RE: CITY OF TUALATIN PLANNING COMMISSION HEARING 12-2-2021

Autumn Sunrise Conditional Use Permit (CUP) 21-0001

Autumn Sunrise Subdivision (SB) 21-0001

Lennar Northwest, Inc. & Applicant's Consultant: AKS Engineering & Forestry, LLC

TRANSPORTATION PLAN

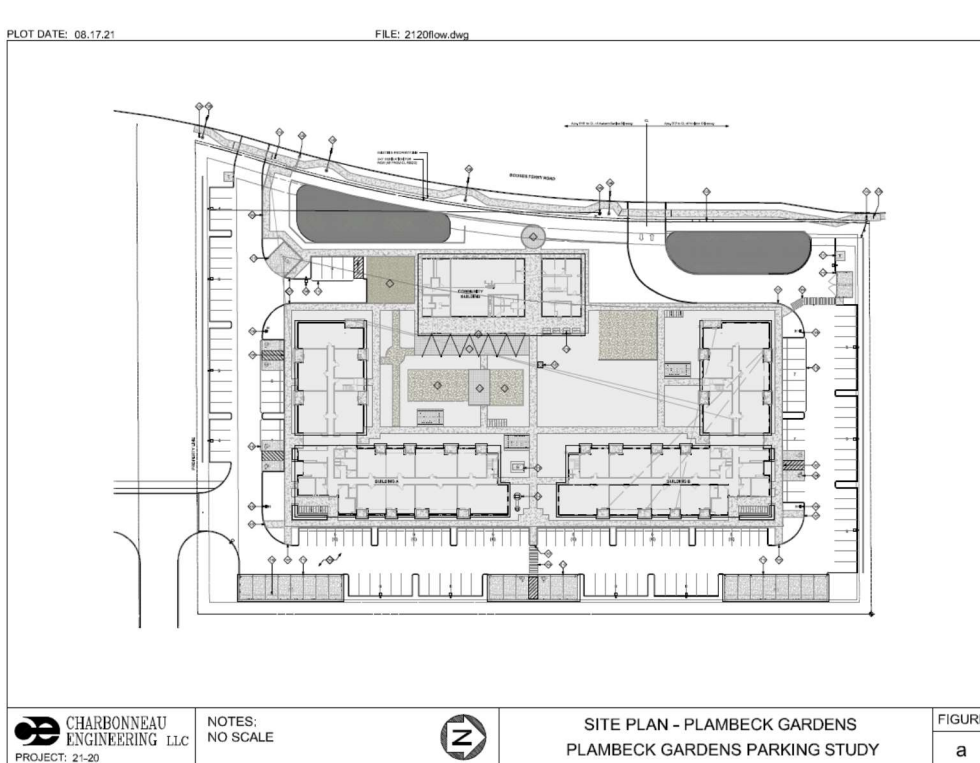
2. There appears to be a discrepancy between the traffic planning for the CPAH property as provided as during the City of Tualatin Planning Commission Hearing on 11-18-2021, for the CPAH Land Use Variances, and the Transportation plan included within the Autumn Sunrise SB21-0001 application.

The proposed Autumn Sunrise Transportation Plan as being presented as part of the City's Land Use Hearing on 12-2-2021, does not indicate vehicular access from the Southern portion of the Autumn Sunrise properties north towards the CPAH property.

Yet, the 8-17-2021 Parking Study presented during the 11-18-2021 CPAH Hearing includes a vehicular access to the south border of their property, indicating connection to a road south of the CPAH property connecting through and past the existing Horizon Church and School road, and apparently onto the Autumn Sunrise properties.

TRANSPORTATION PLAN

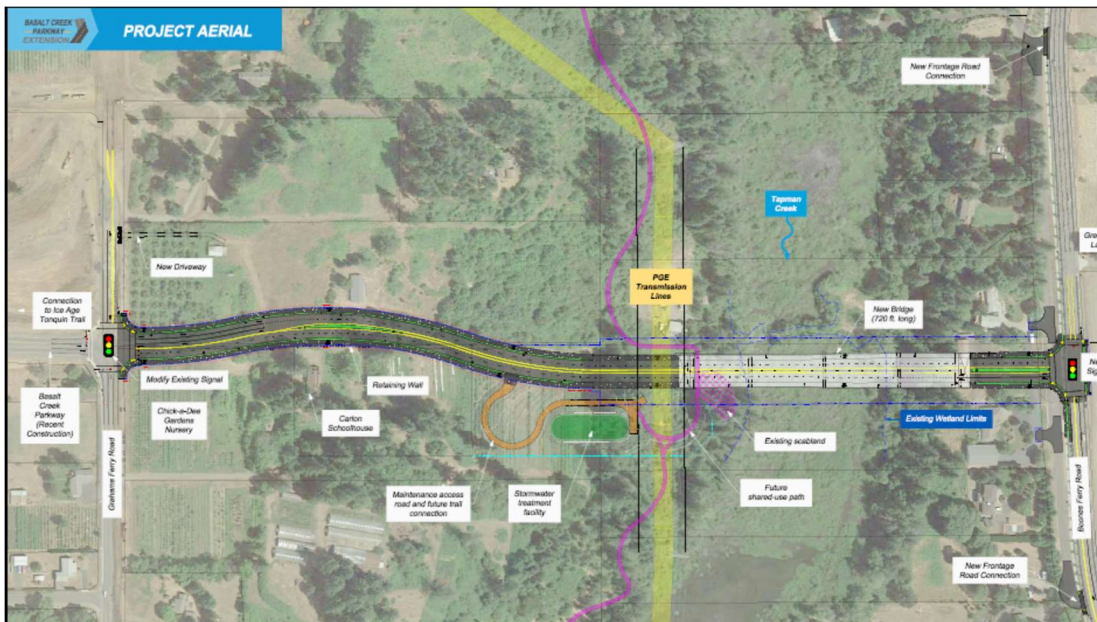
3. The Transportation Plan copied above also appears to omit identification of vehicular access for a 50,000 vehicle to provide service and maintenance for the proposed Southern Stormwater Collection and treatment facility along SW Boones Ferry Road as provided in **TDC 74.350. Maintenance Easement or Lots.**
4. The Autumn Sunrise Subdivision application provides little information as to the coordination and integration of Washington County's Basalt Creek Parkway Extension as presented within SB21-0001, and the apparent discrepancies with Washington County's most currently posted 10-20-2020 Boones Ferry Road Access Reconfiguration Map as to the location and positioning of the future intersection of the Basalt Creek Parkway Extension onto SW Boones Ferry Road and its alinement to Greenhill Lane.

PRE-DEVELOPED BASIN DELINEATION		FIGURE
AUTUMN SUNRISE SUBDIVISION		2
AKS ENGINEERING & FORESTRY, LLC 12965 SW HERMAN RD, STE 100 TUALATIN, OR 97062 503.563.6151 WWW.AKS-ENG.COM		DRWN: JSM CHKD: DS AKS JOB: 7454

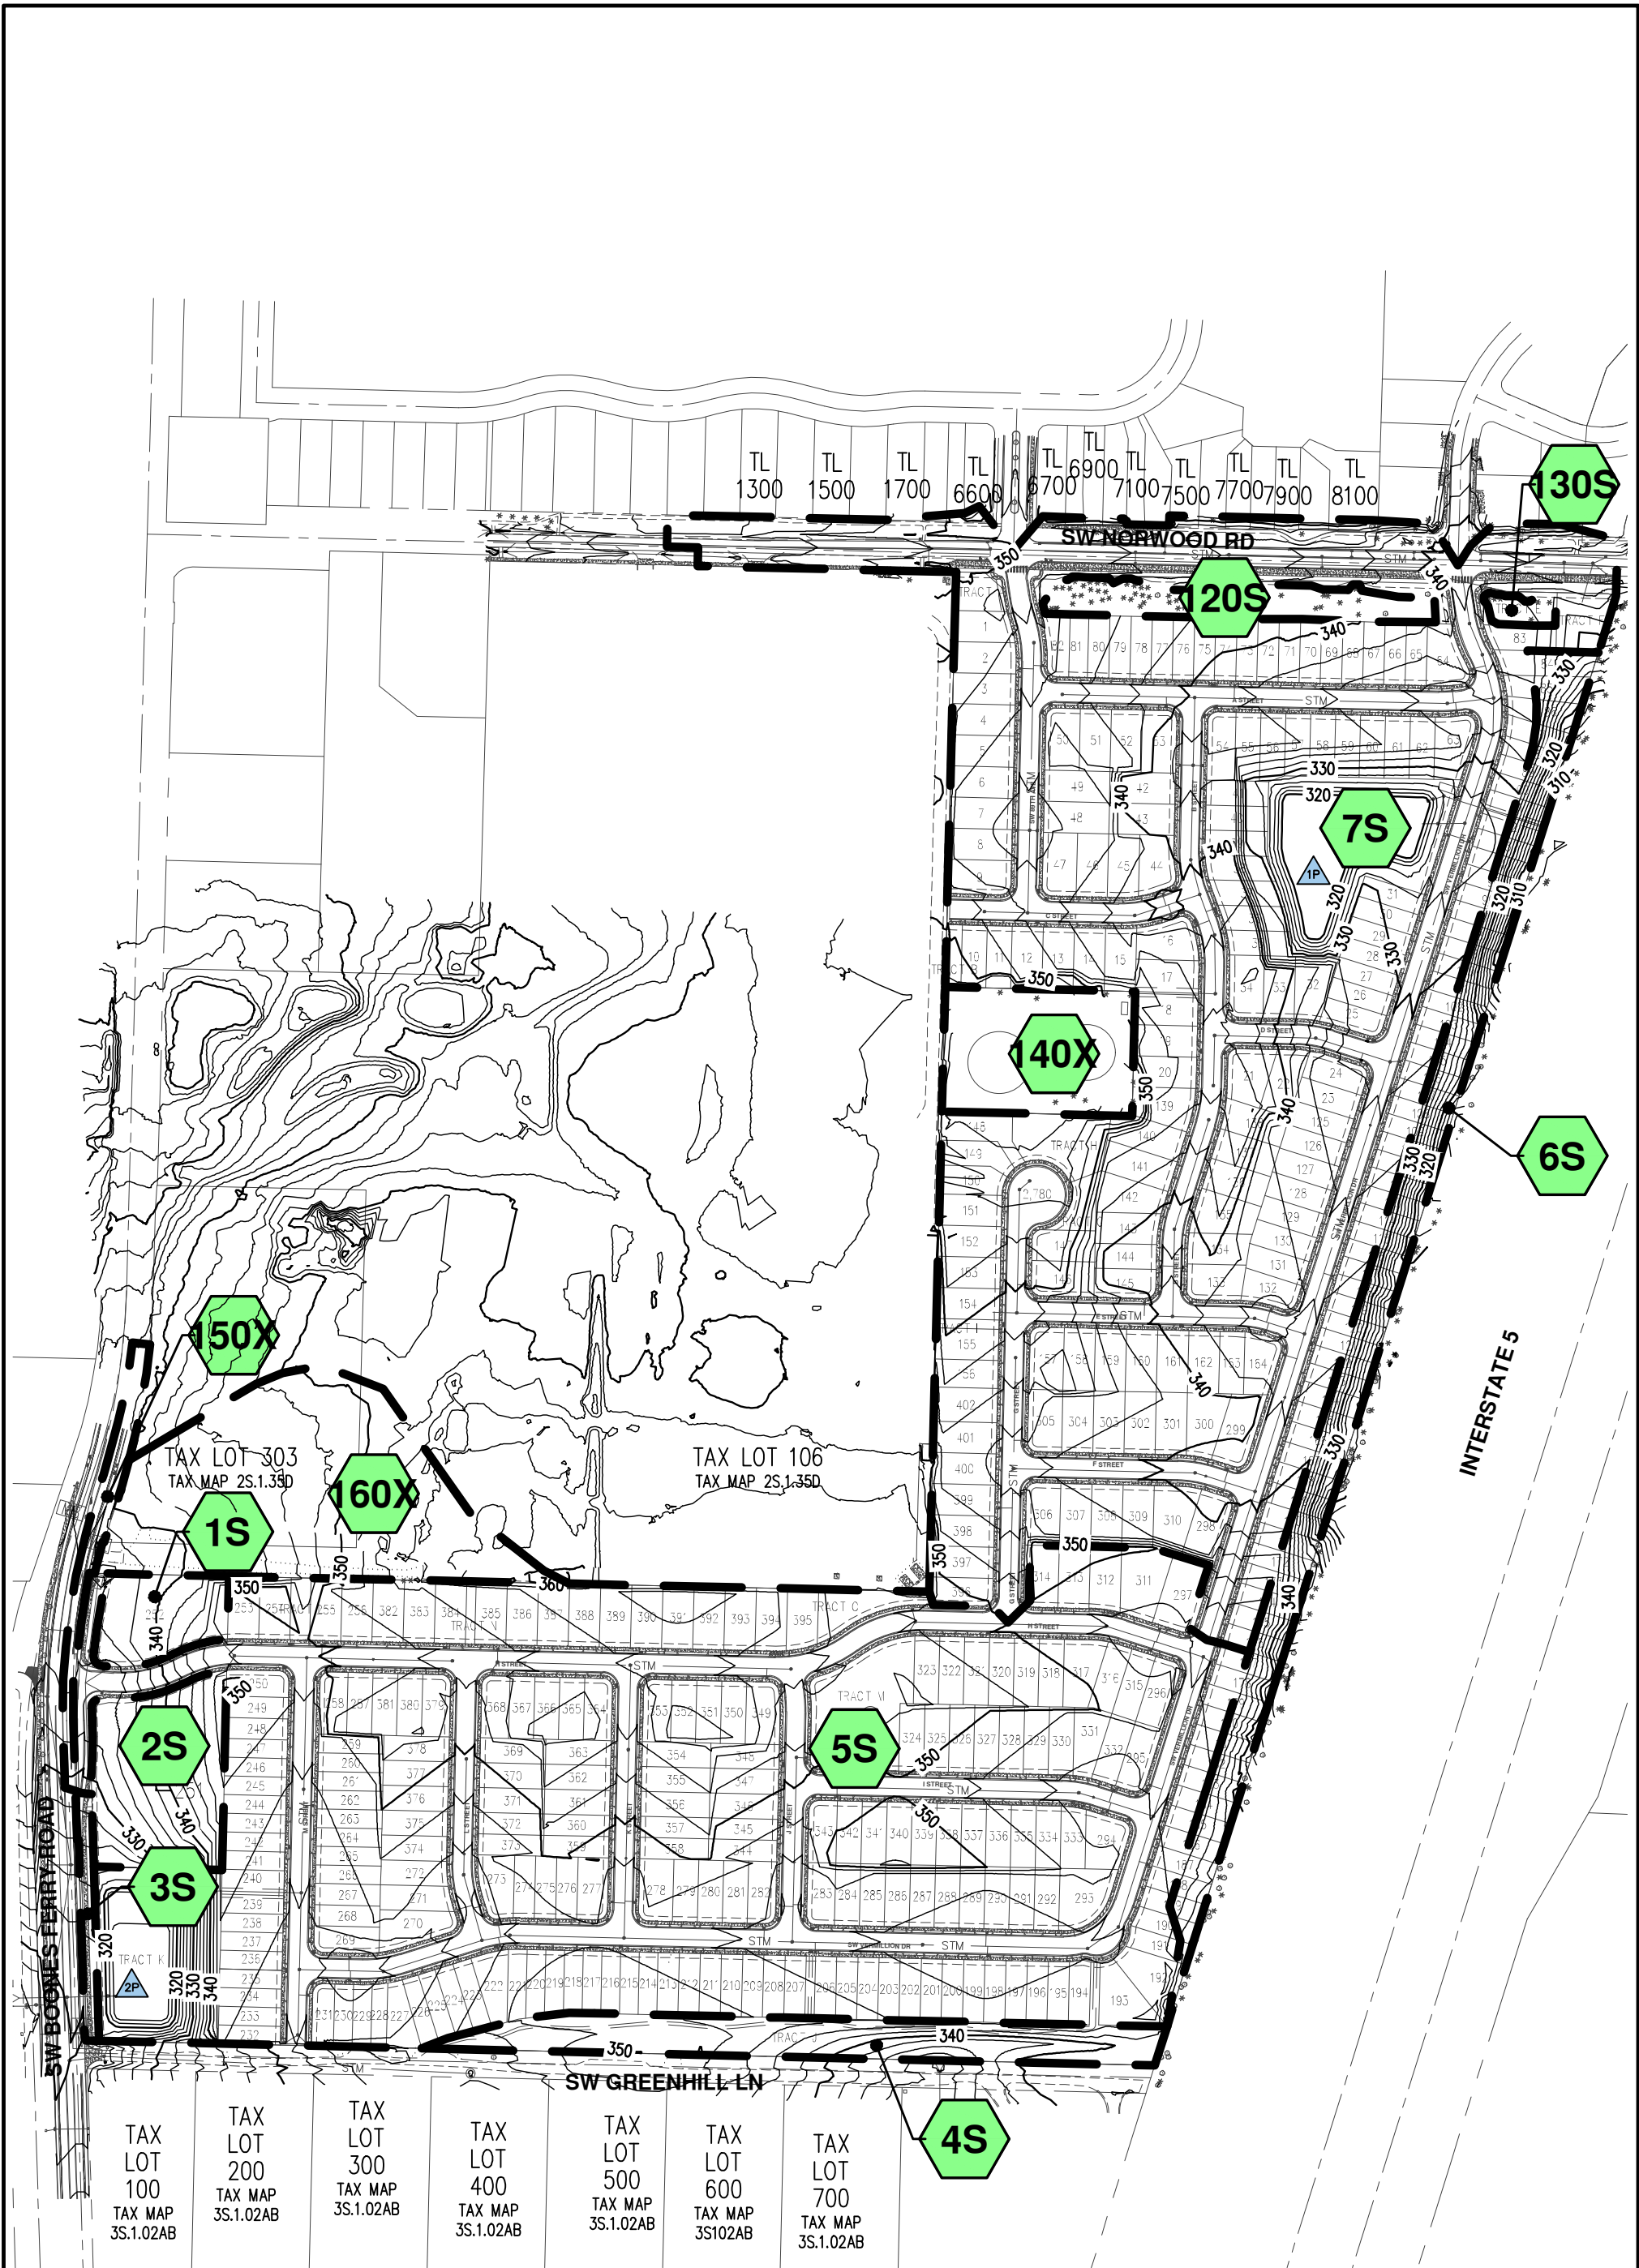
Stormwater modeling of rainfall runoff by AKS is non-representative and is simulated as primarily undeveloped. It is known that the CPAH site will be an intensely urban development. This underscores the problem of a lack of a City of Tualatin Stormwater Master Plan. Communication and apparent coordination are affected between Lennar, CPAH, CWS, City of Tualatin and other affected agencies.

STORM OUTFALL #5 PLAN AND PROFILE

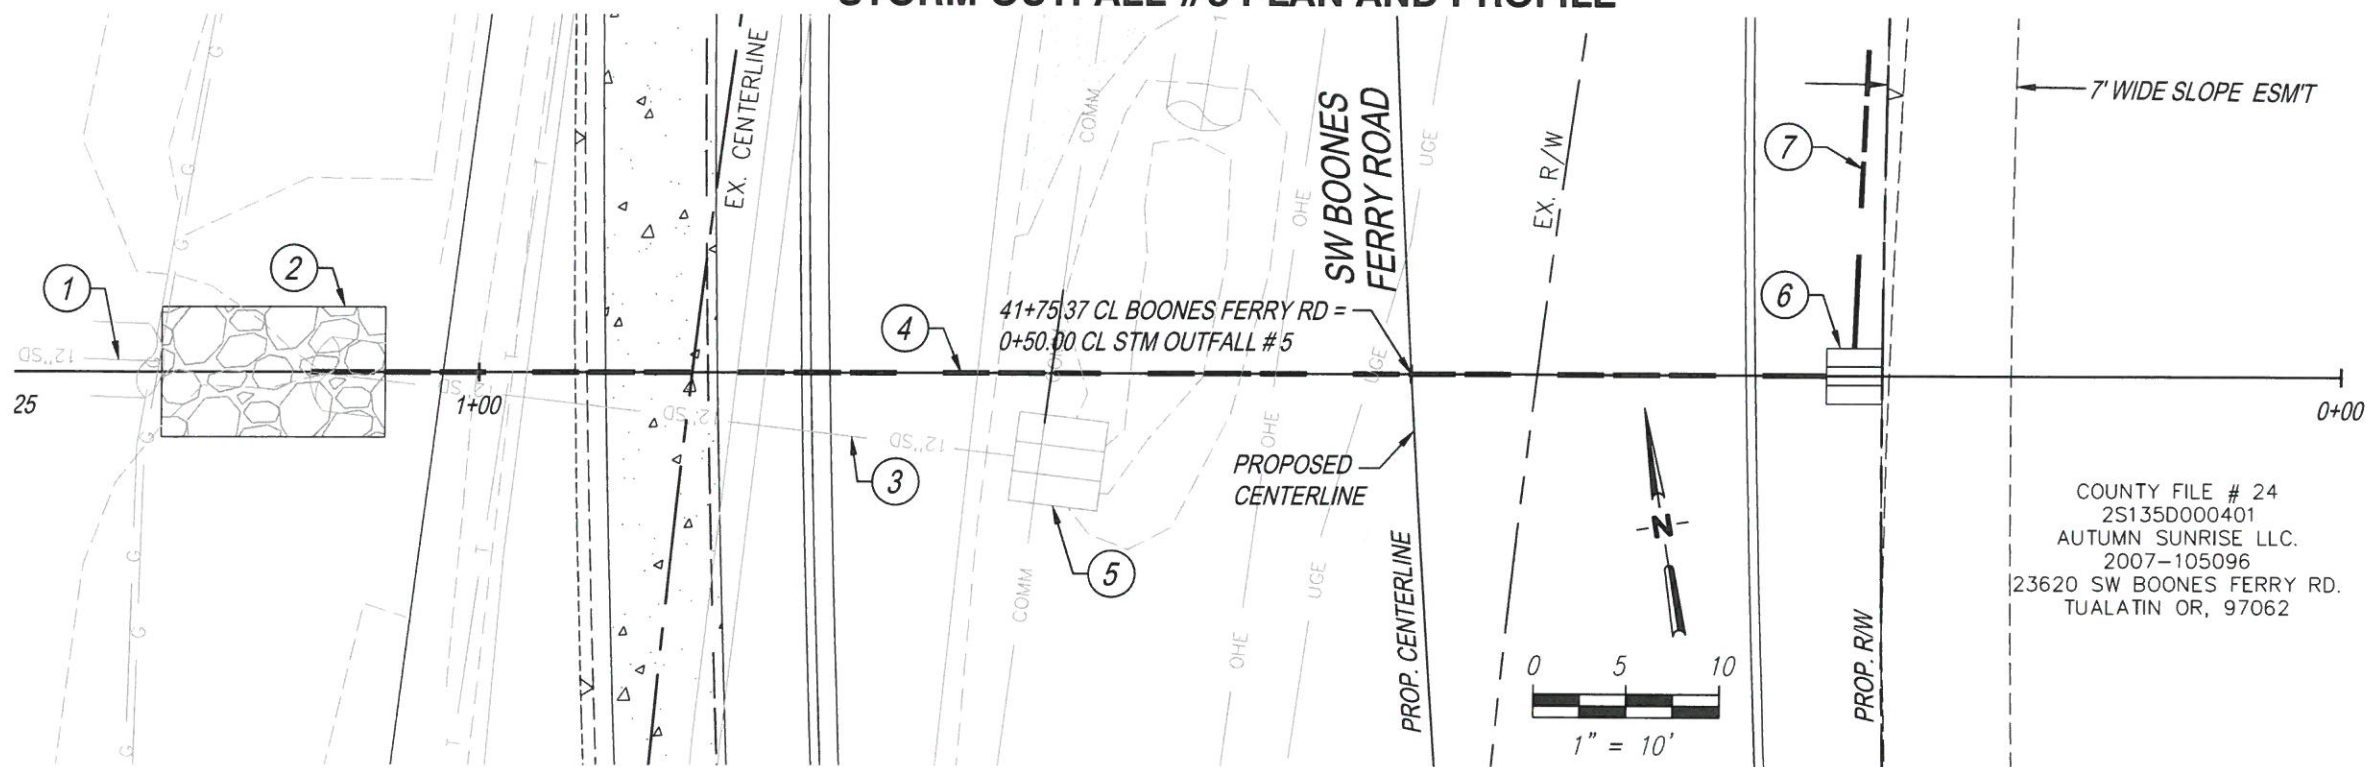
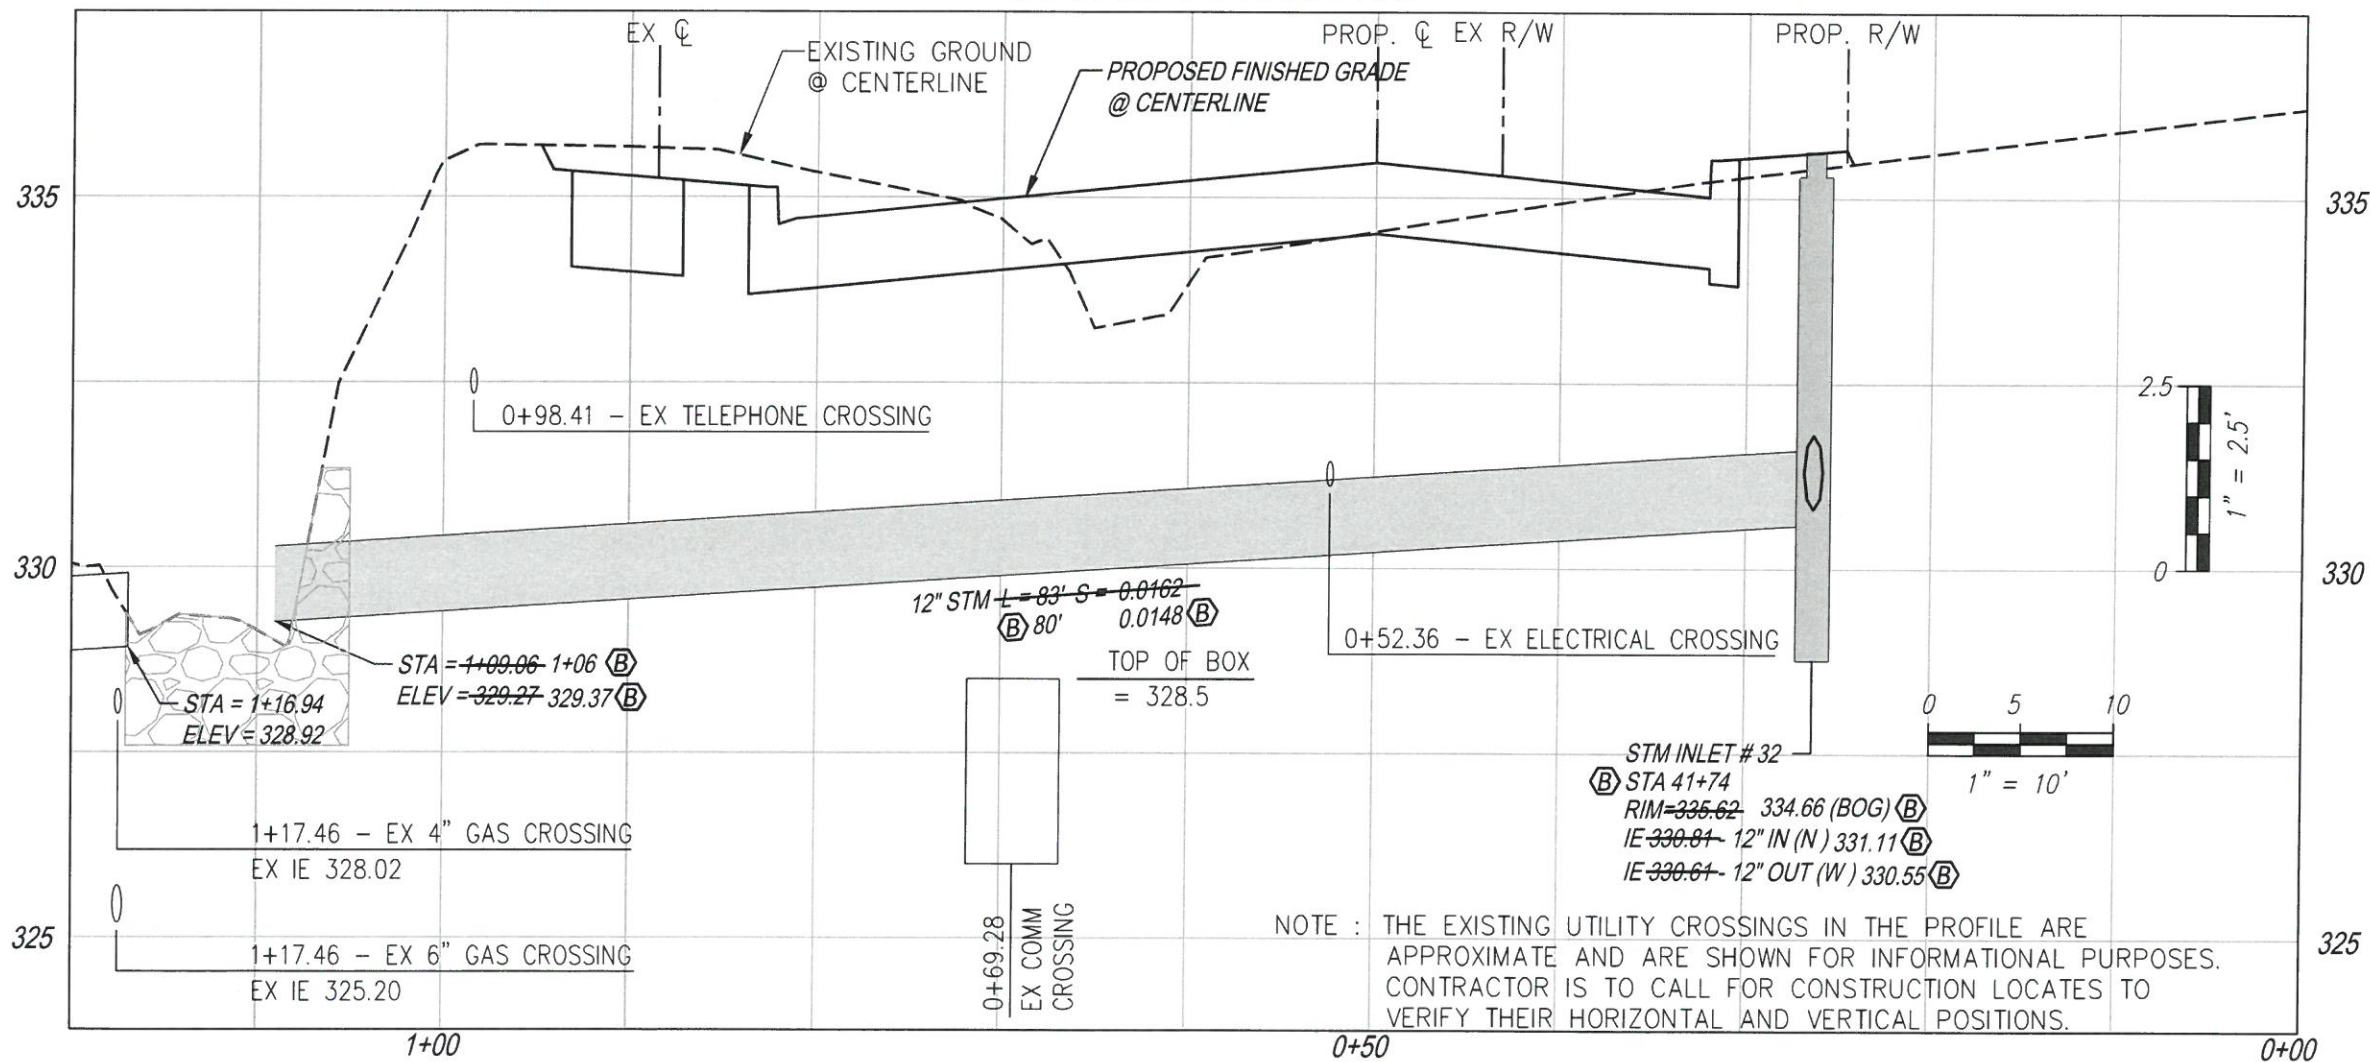
- As presently planned, storm flows from the new CPAH and AS developments can flow into Washington County's Boones Ferry Road Storm Outfall #5 (see Appendix C). This outfall discharges directly onto the Lucini property.

As presently planned, storm flows from the new CPAH and AS developments can flow into Washington County's Boones Ferry Road Storm Outfall #5 (see Appendix C). This outfall discharges directly onto the Lucini property.

The AS demolition plan DP-04 indicates that the existing storm pipe in BFR is to be discontinued (see Plans Notes 16 through 19). This piping section is labeled as Outfall #5 in the Washington County BFR Widening Project (see excerpt in Appendix C). This 12-inch outfall discharges directly to the Lucini property from the proposed AS.

1. **The Planning Commission requires as a Condition the Autumn Sunrise Subdivision Approval -The removal of Washington County Stormwater Outfall #5 and the Stormwater culvert under BFR currently draining onto our property be removed, and the stormwater collected in the remaining outfall be directed to the proposed Lennar Stormwater facility on the SW portion of the August Sunrise property- as has been identified within the Autumn Sunrise SB21-0001 application.**
